# London Luton Airport Expansion

**8.178 Applicant's Response to Examining Authority's Rule  
17 Request dated 17 January 2024**

Application Document Ref: TR020001/APP/8.178

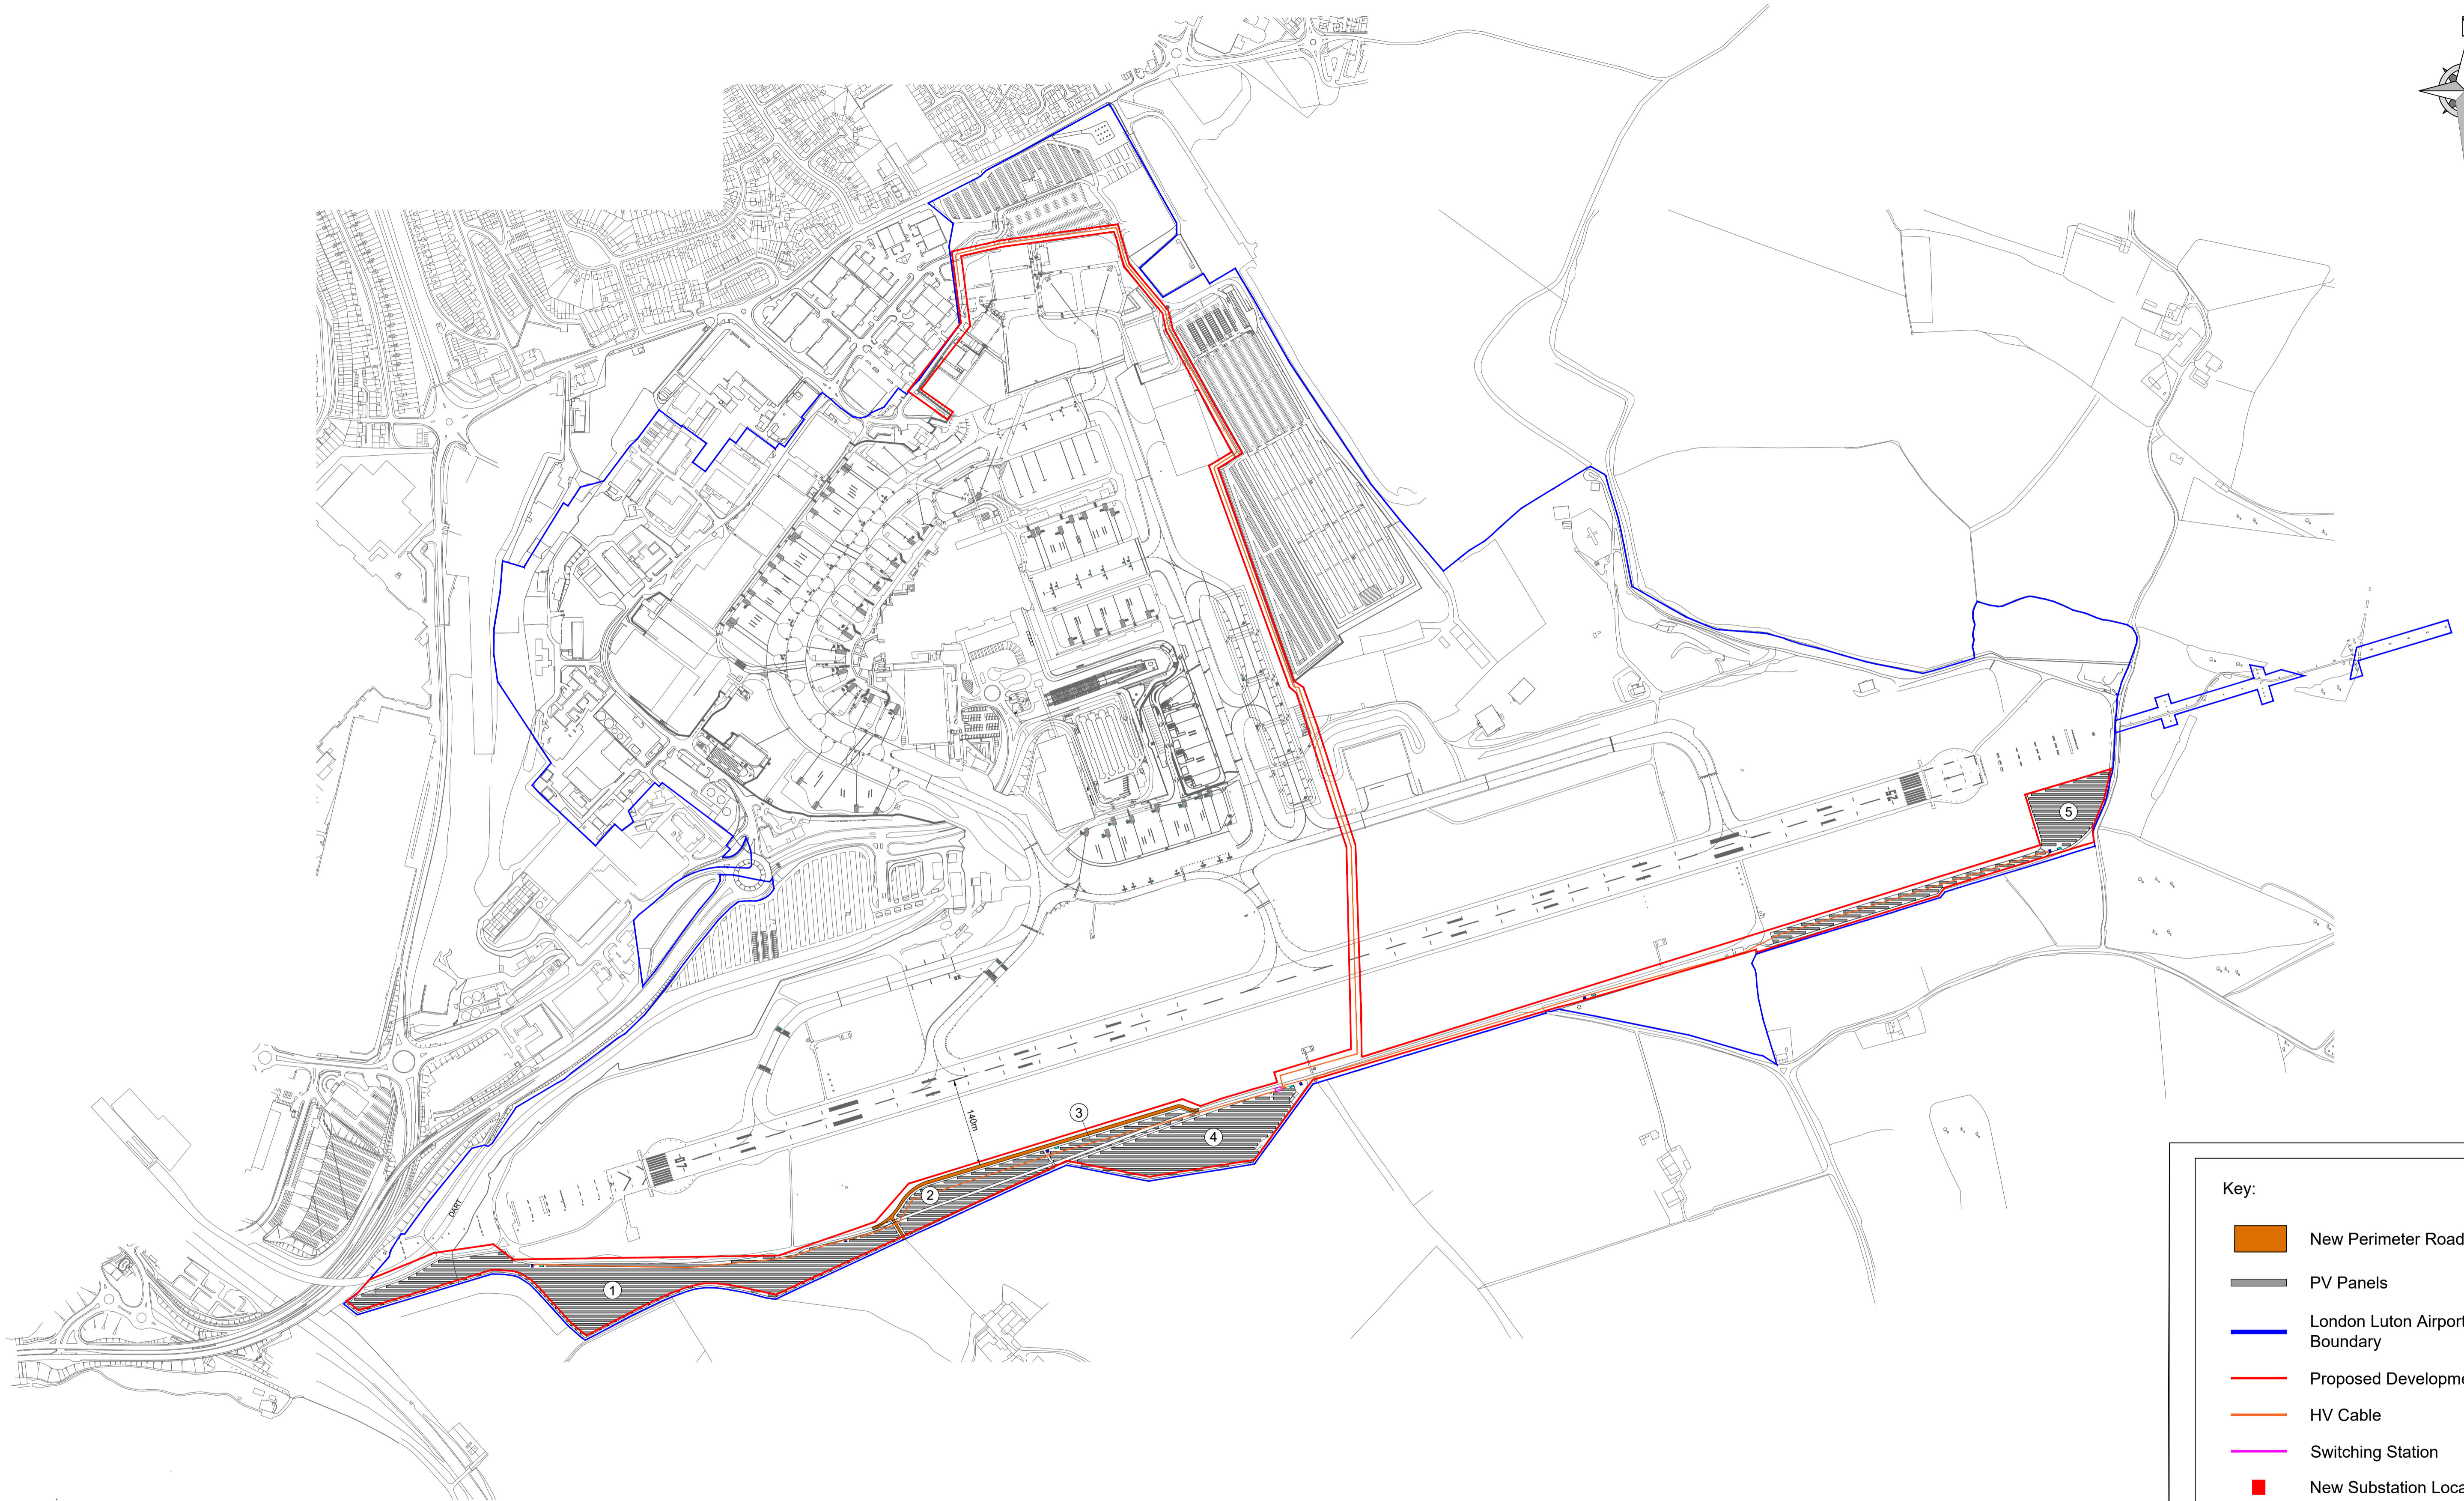
Ref.	ExA Request [PD-019]
2	<p><b>Luton Borough Council (LBC), Central Bedfordshire Council and the Applicant - Solar Farm on Land to the South of the Runway (LBC ref: 23/01314/GPDOPD and CBC ref: CB/23/03617/OAC)</b></p> <p>The ExA notes the responses from LBC [REP7-090] and Central Bedfordshire Council [REP7084] to its further written question BCG.2.4, advising that they issued a decision for the creation of a solar farm on land to the south of the runway, which confirmed that the proposal constitutes permitted development.</p> <p>Please provide a copy of the plans for this development and advise of any implications for the current application.</p> <p>As the solar farm development is now in the consented baseline, the Applicant is requested to submit further information setting out any implications on the Proposed Development and the findings of the Environmental Statement (ES). This should include any potential changes to the Landscape and Visual Impact Assessment, and Cultural Heritage, with reference to Luton Hoo and Someries Castle. This element of the response can be submitted at D9.</p>

- 2.1.1 The description below is taken from the application letter submitted as part of the application (23/01314/GPDOPD). The layout of the Solar Farm as proposed by London Luton Airport Operations Limited (LLAOL) is shown on the site layout plan included in Appendix A to this document.

- 2.1.2 Solar Photovoltaic (PV) panels will be installed across five development areas along the southern boundary of the airport site. The panels, covering an area up to approximately 96,780 m<sup>2</sup>, will be secured onto steel frames and constructed as a series of arrays. At their highest point, the panels will be 3.0m tall, dependent on the angle of the panels.

- 2.1.3 The solar PV panels will connect to up to six new substations located across the Solar Farm site. Measuring approximately 2.0m in height, 3.5m in width and 4.0m in length, the substations will include switchgear, transformers and cable supports. They will be mounted on plinths and will be enclosed by 1.8m high metal palisade fencing.
